Access Compliance Report

Public Rights-of-Way

(Curb Ramps)

Intersection ID: 12176	Main Street: NASSAU_BV	Cross Street: THURMOND_PL	Location: NW
ADA ID: C97B087DFFA5	Ramp Type: PerpDiag	Initial Pass/Fail: Fail	Overall Compliance: No
		Severity Score: 33.75

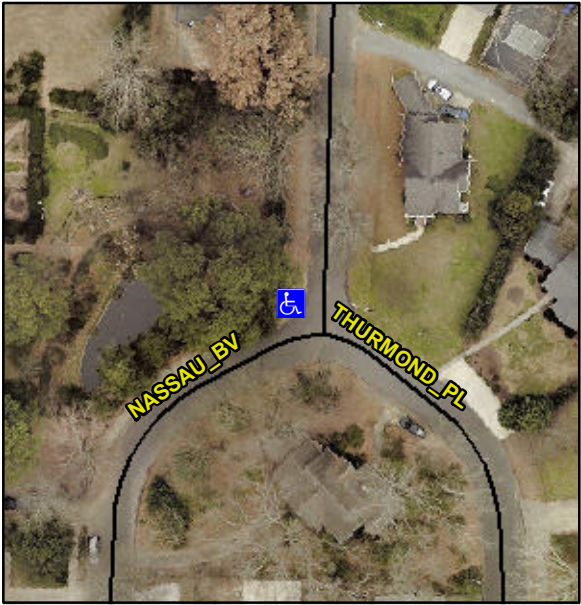
Codes/Mitigation Info/Possible Solution			Field Measurements/Component Compliance		
	Possible Solutions:		Compliance	Description	Data
	Remove & Replace Curb Ramp With Two New Directional Ramps or Equivalent.		Yes	Ramp Length (in)	72.0
			No	Ramp Width (in)	47.0
			N/A	Flare Type LT	N/A
			N/A	Flare Slope LT (%)	N/A
			N/A	Flare Traversable LT?	N/A
			N/A	Landing Length (in)	N/A
			N/A	Landing Width (in)	N/A
			N/A	Landing Slope (%)	N/A
			N/A	Landing X Slope (%)	N/A
<p>Surveyor Notes:</p> <p>N/A</p> <p>PROW/ADA:</p> <p>Not Found, R304.5.1, R304.5.3</p>			N/A	Flare Type RT	N/A
			N/A	Flare Slope RT (%)	N/A
			N/A	Flare Traversable RT?	N/A
			N/A	DWS Provided?	N/A
			N/A	DWS Contrast?	N/A
			N/A	DWS Length (in)	N/A
			N/A	DWS Full Width?	N/A
			N/A	DWS Offset (in)	N/A
			N/A	Gutter Ponding?	N/A
			N/A	Gutter Lip Ht (in)	N/A
			No	Painted X Walk1?	N/A
			To S	X Walk 1 Direction	To E
			N/A	X Walk 1 Width (in)	N/A
			N/A	X Walk 1 Slope (%)	N/A

N/A	X Walk 1 X Slope (%)	N/A
			N/A	Ramp inside XWalk1?	N/A
			5.3	Road Slope (%)	N/A
			1.5	Road X Slope (%)	N/A
			N/A	Any Obstructions?	N/A
				Obstruction Type	
Total Cost:		\$ 3200.00	N/A	Clear Space?	N/A
			N/A	Clear Space to XWalk (in)	N/A
			N/A	Storm Grate/Utility Hazard?	N/A
				Storm Grate/Utility Type	
			N/A		N/A
			Yes	Surface Condition? (G/P)	Good
